**PLANNING COMMISSION
Regular Meeting
Monday, November 22, 2021
6:00 PM
Christine Nuernberg Hall**

TO: Planning Commission
FROM: PA PHOUALA VANG, PLANNER
DATE: November 22, 2021
SUBJECT: North Shore Bank. The applicant is seeking conditional use grant extension approval for the previously approved bank building with a rear drive-through for the property located at 11319 N. Port Washington Road. This was previously approved in October 2020.

TO: Planning Commission
FROM: PA PHOUALA VANG, PLANNER
DATE: November 22, 2021
SUBJECT: Applied Buildings, LLC. The applicant is seeking building and site plan and fill approval for a proposed 36,843 sq. ft. multi-tenant office/warehouse building and certified survey map approval to allow for a 3-lot land division for the property located a 5715 W. Donges Bay Road.

SHEET
FACILITY PLANS

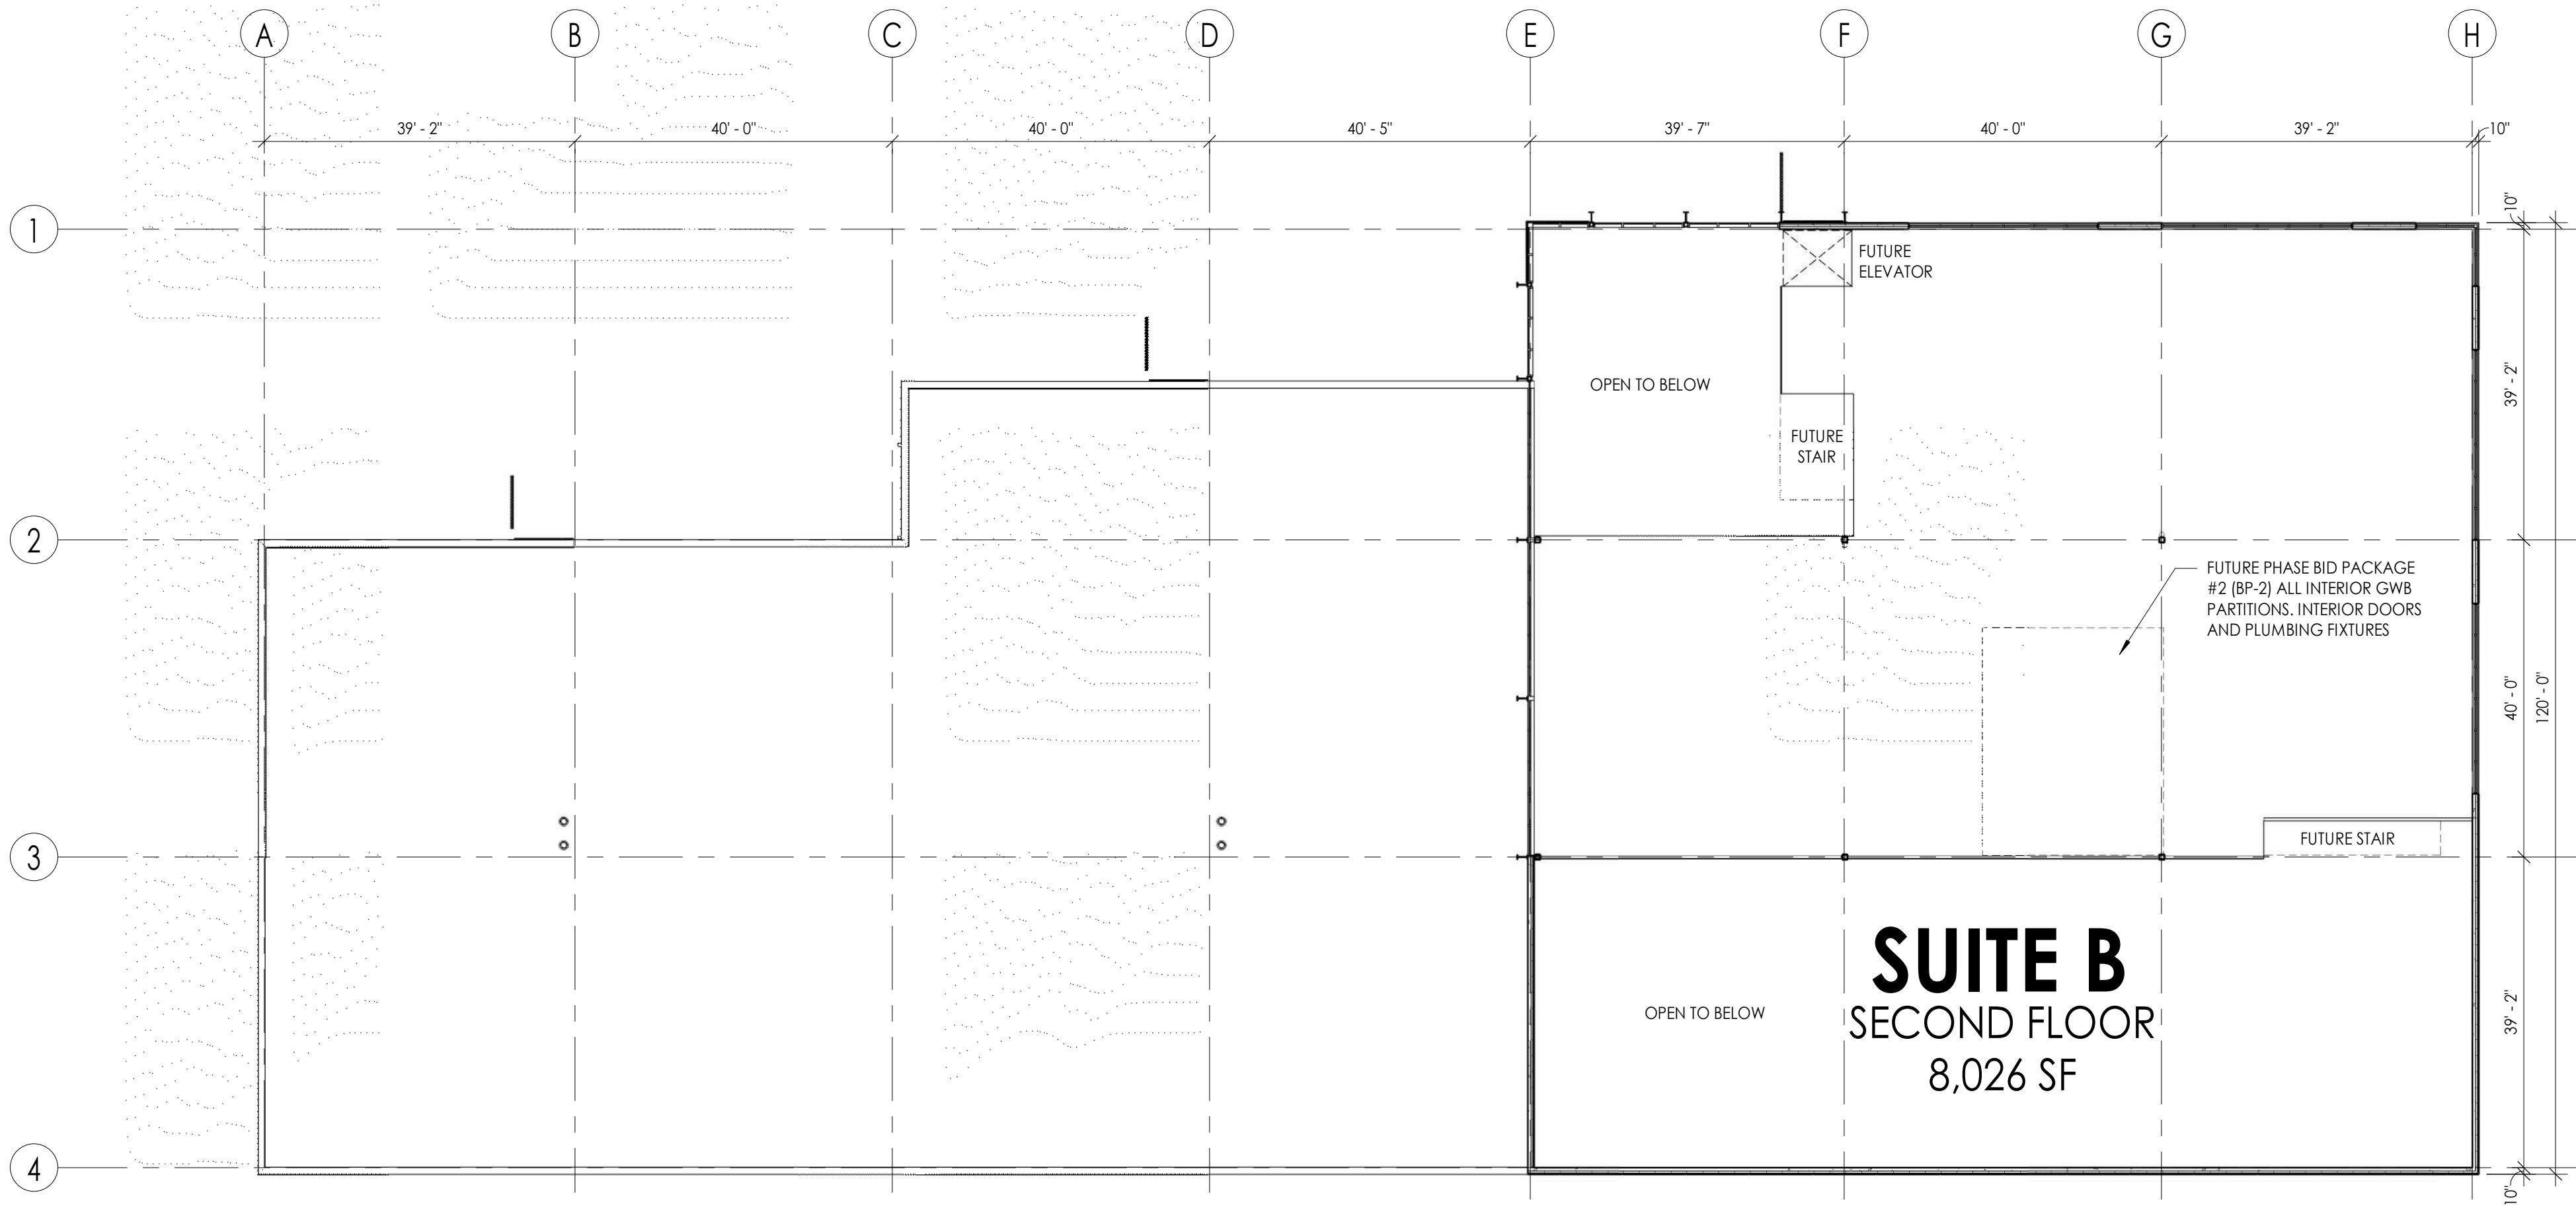
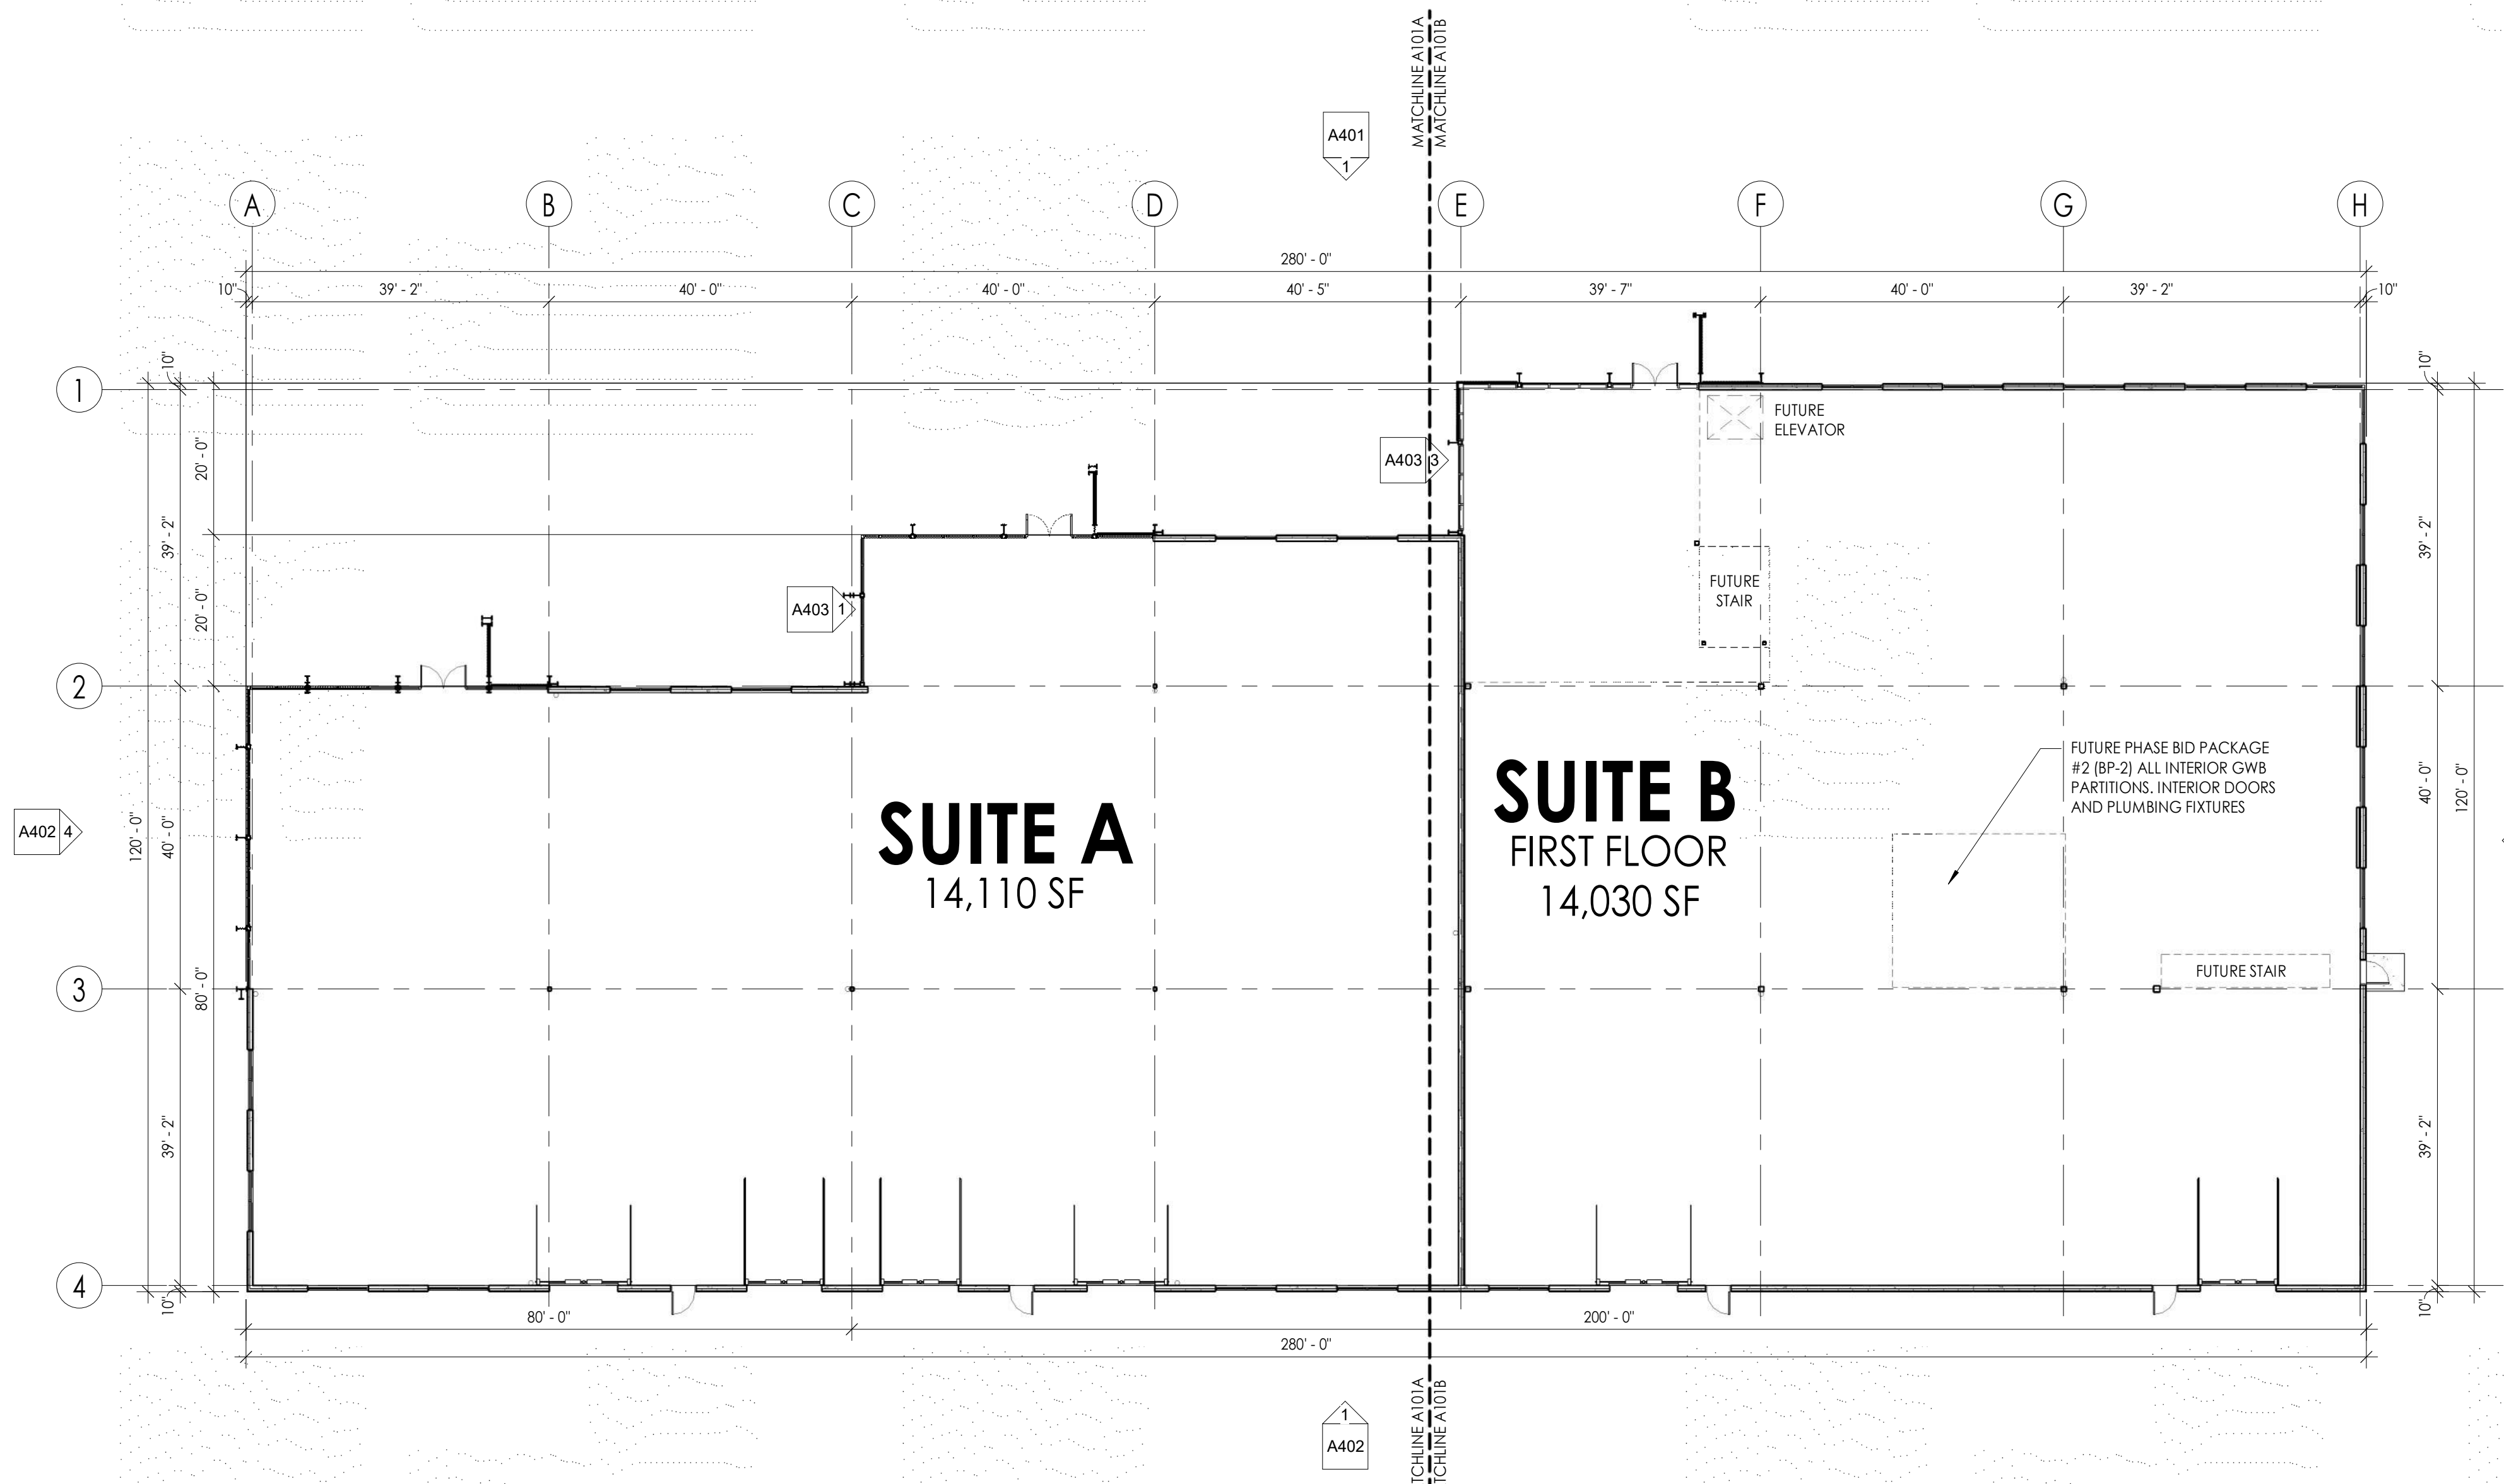
The floor plan shows a two-story multi-tenant building. The plans show two suites of approximately 14,000 square feet each on the first floor. Suite B will be offices for HVA Products, Inc. and Specialty Software Group. Suite B also shows an 8,026 square foot second floor. A portion of Suite B will be used as warehouse space for staging and stocking equipment for HVA Products. Suite A is vacant and will be used for future expansion and/or tenant build outs.

CONSTRUCTION PLAN - ROOF

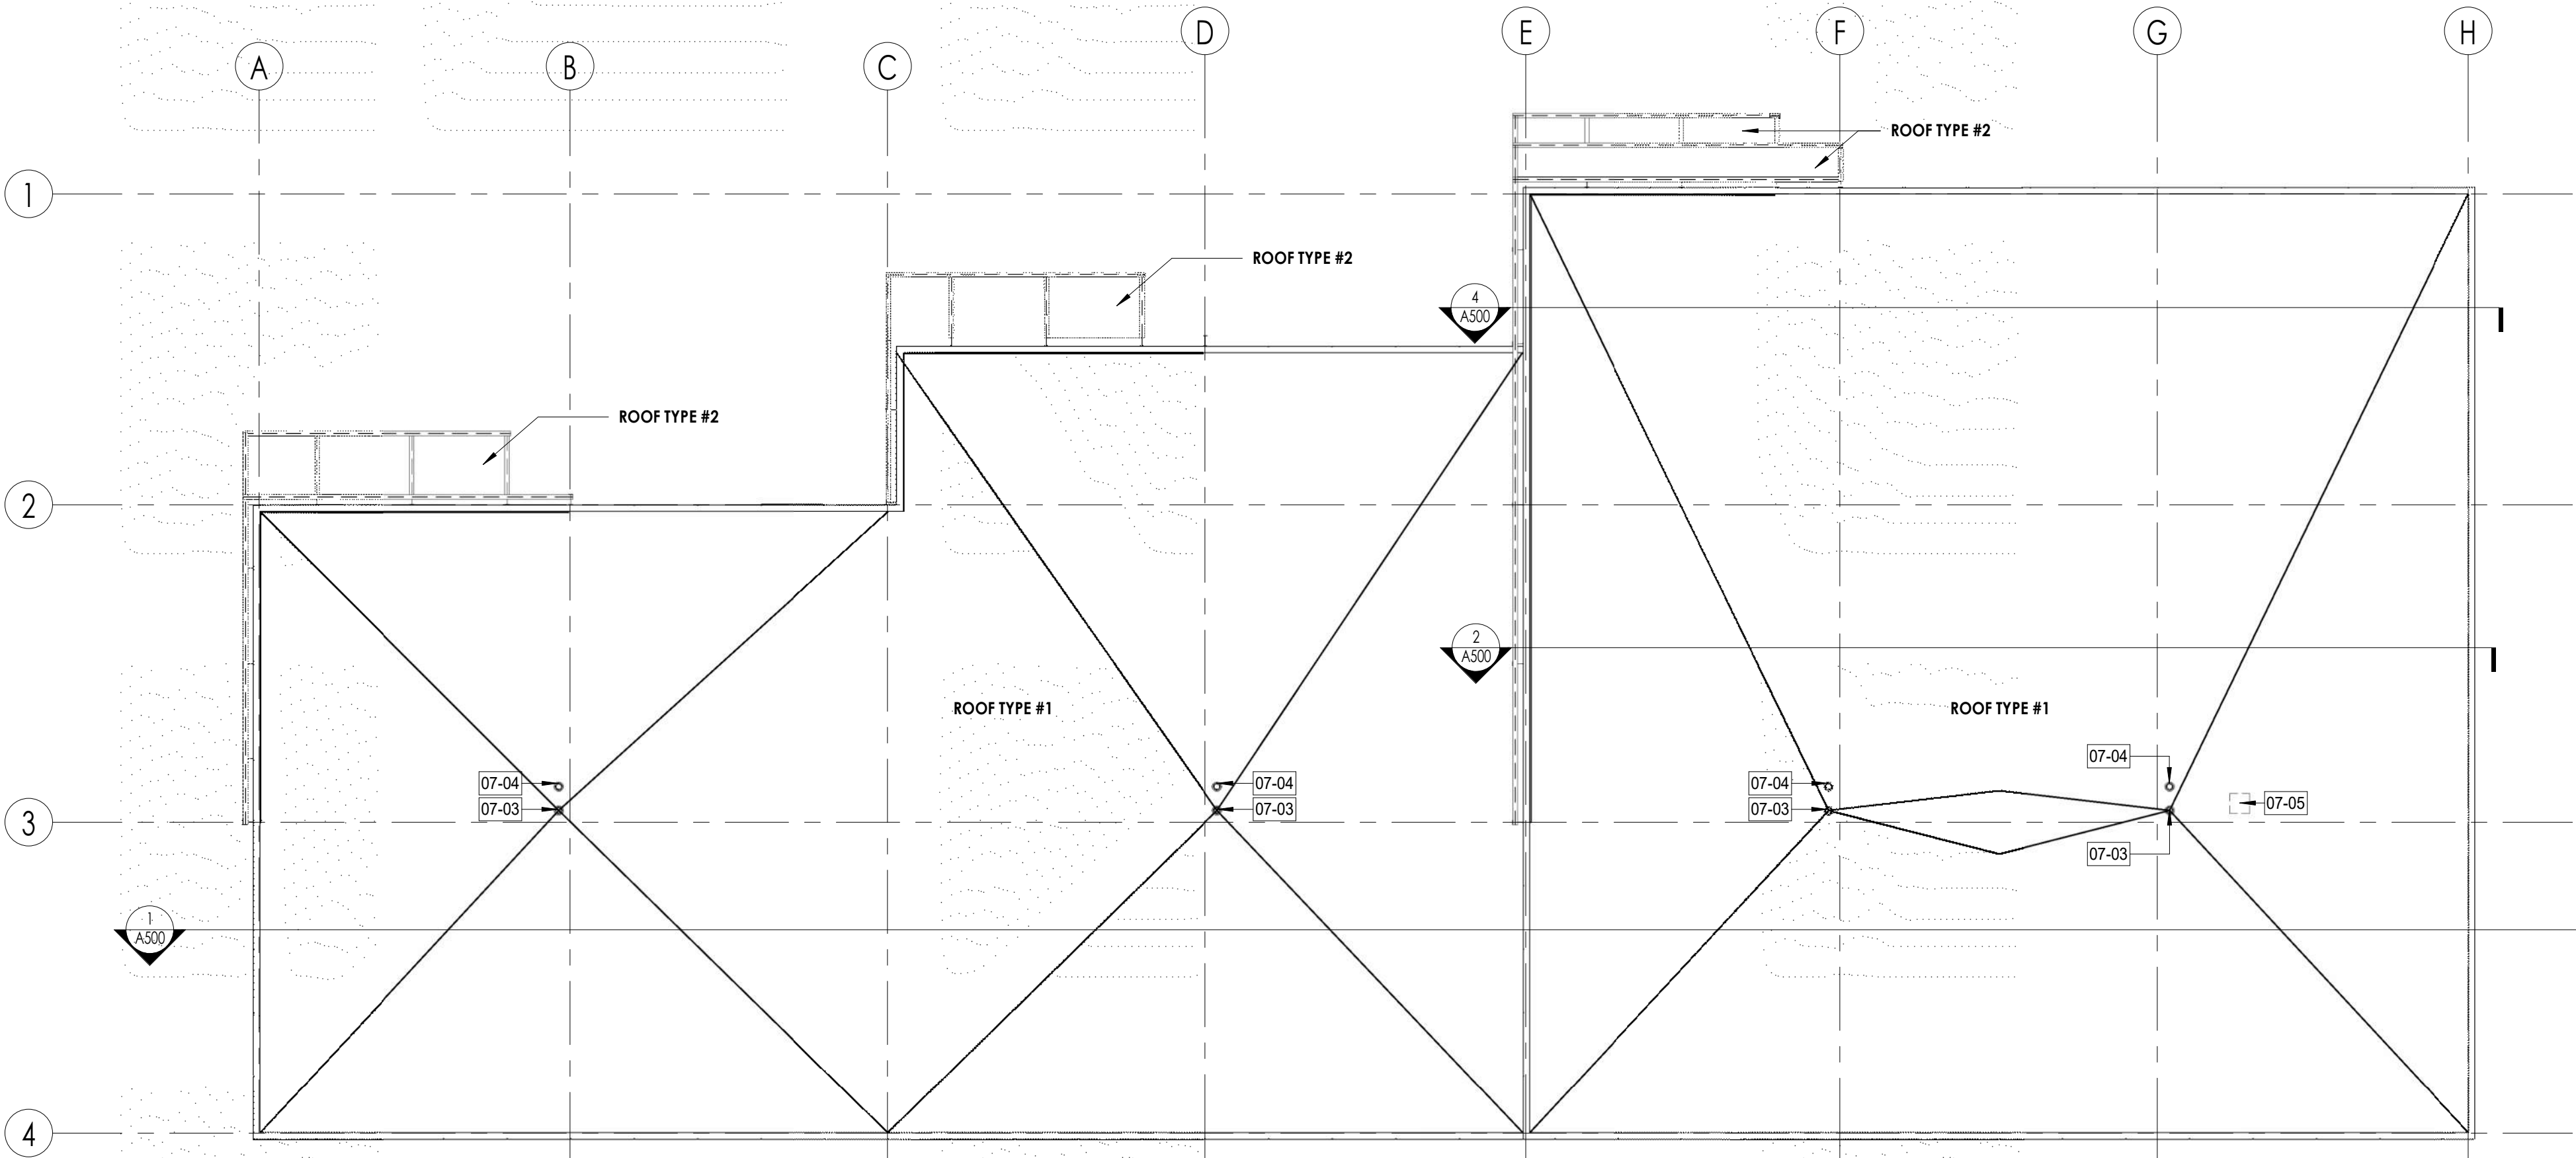
No rooftop screening is shown on plans or proposed at this time. A condition states that rooftop screening shall be required if the rooftop units are visible from street view once construction is complete.
